**Comhairle Chontae Chill Chainnigh
Kilkenny County Council
Planning Report**

Planning Ref: P. 26/ 60389

Subject: Permission to construct a dormer style dwelling, new entrance with associated wing walls, appropriate waste water treatment system, bored well, single storey domestic garage, ground mounted PV solar panels, all ancillary site works and landscaping at Killeen, Kilmanagh, Co. Kilkenny.

Mottling noted in trial hole within 500mm of ground level during site inspection on 6th August 2026

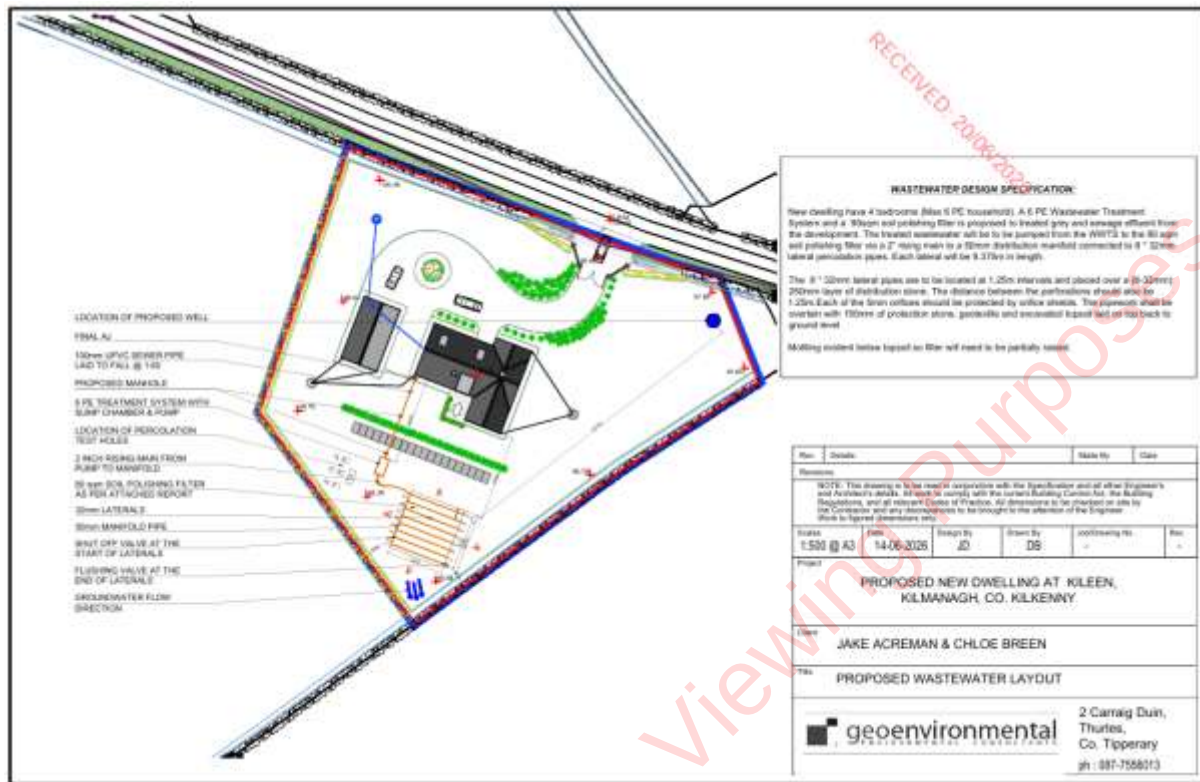
1. A site visit was carried out on 06/08/2026 where the following was observed:
 - a. Mottling was noted within 500mm below ground level
 - b. Water was noted in the trial hole at 1.7m below ground level

Having regard to the mottling noted within 500mm of ground level during site inspection on 6th August 2026, together with the documentation submitted and the report from the Environment section, it has not been demonstrated that the site is capable of accommodating an on-site wastewater treatment system.

Proposed water and wastewater layout plan

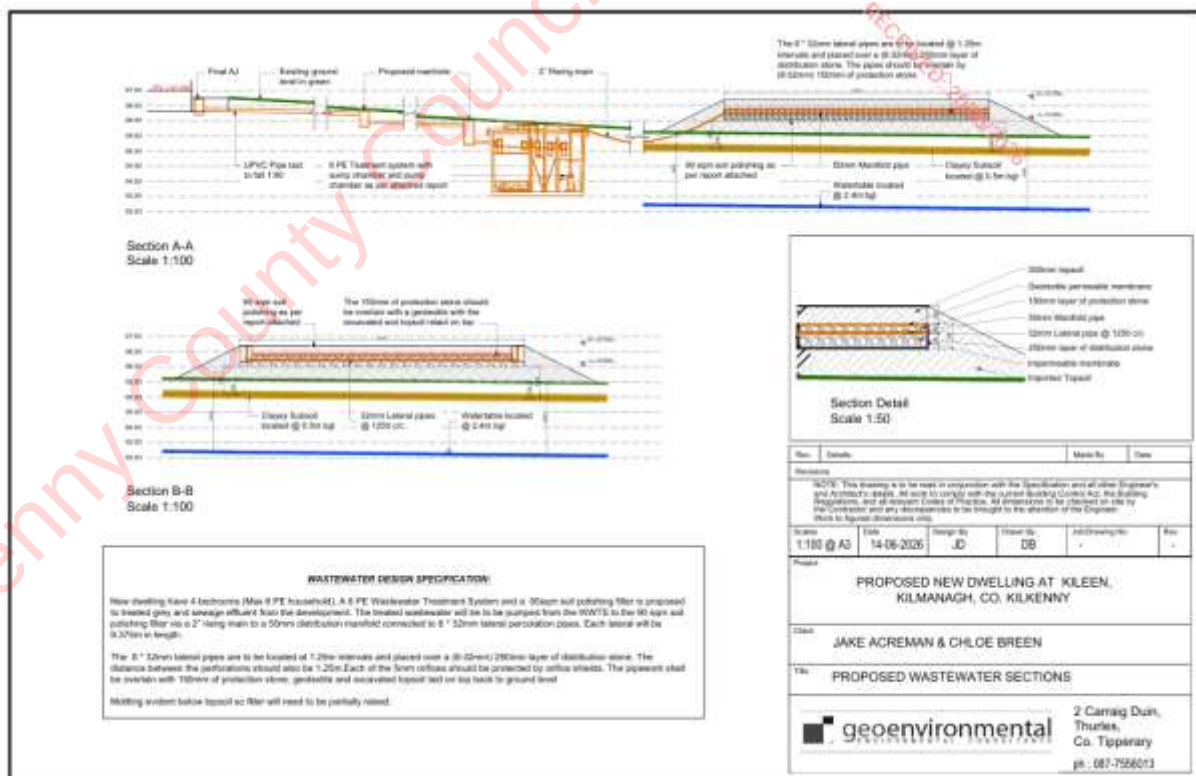
Surface water – proposed disposal to on-site soakpit. Notes on file state ‘Proposed overrun from soakpits into drainage ditch’; should the applicant be progressed the applicant would need to address proposals for all surface water run-off to be contained within the site boundaries, without discharge to adjoining drains including infiltration testing as appropriate.

- a shallow slope between 1:5-1:20,
- mottling was noted within 05.m of ground level in the trial hole which had a stated depth of 2.5m,
- a sub-surface test value of 35.53 and surface-test value of 20.28 were recorded;
- proposed secondary wastewater treatment system and polishing filter / septic tank and percolation area.

The applicant has not adequately demonstrated that the site is capable of the safe disposal of treated effluent without risk to public health. The proposed development is therefore considered to be contrary to proper planning, protection of the environment and the sustainable development of the area.

1. Having regard to mottling noted within 500mm below ground level in the trial hole on site during site inspection, and documentation and proposals submitted with the application, the applicant has failed to demonstrate that wastewater and surface water can be adequately catered for on site without risk to the environment and public health; the development as proposed would therefore be contrary to the proper planning and sustainable development of the area.

Proposed wastewater treatment system section

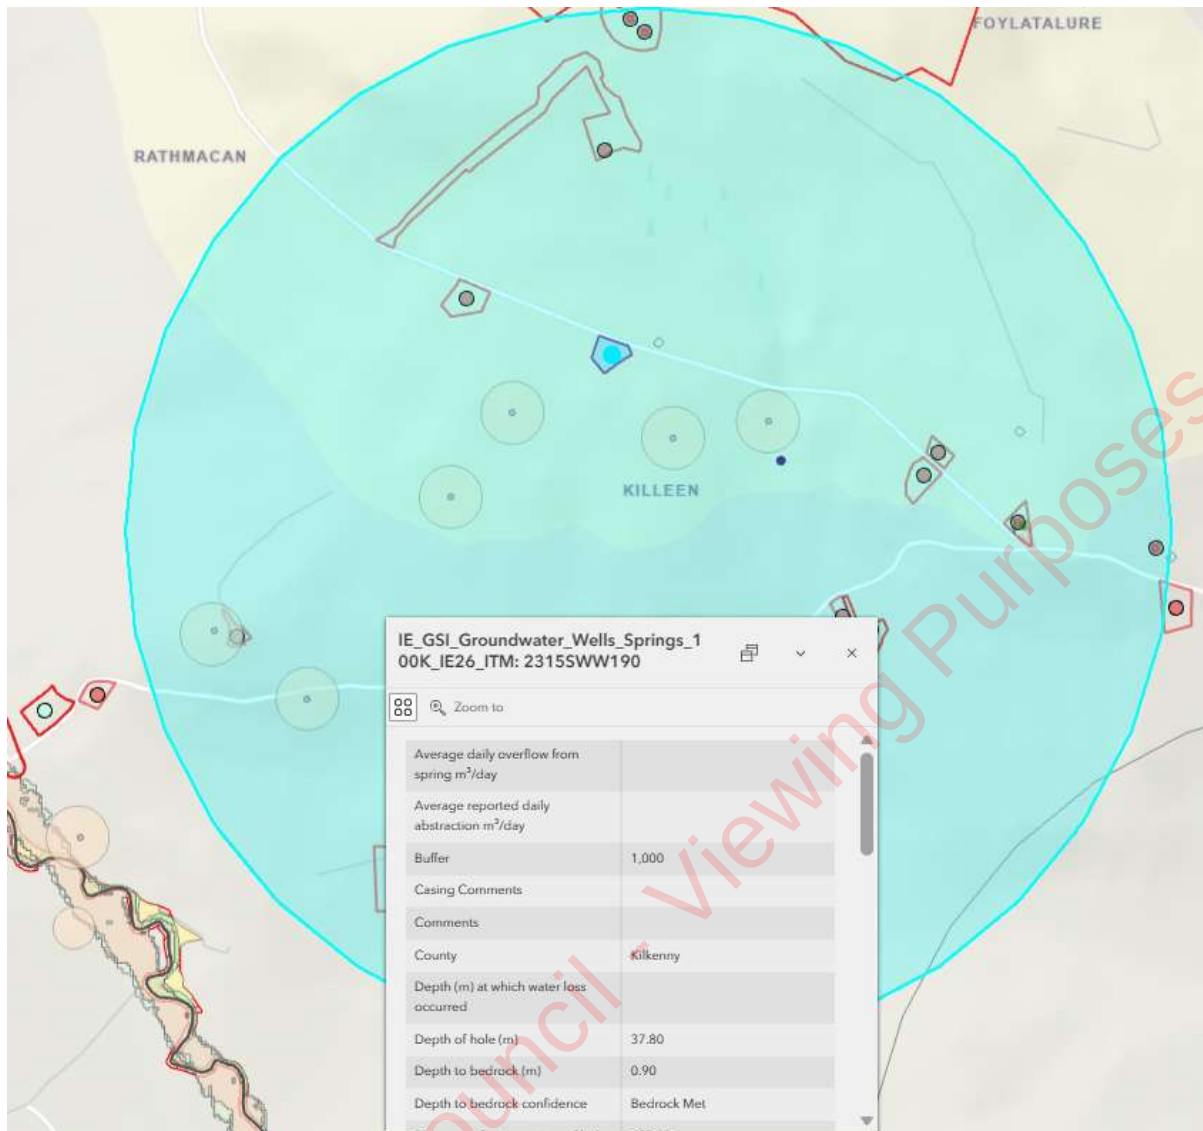
1. *There is not enough evidence to support that effluent resulting from the proposed development will not cause undue harm to human health or the environment.*
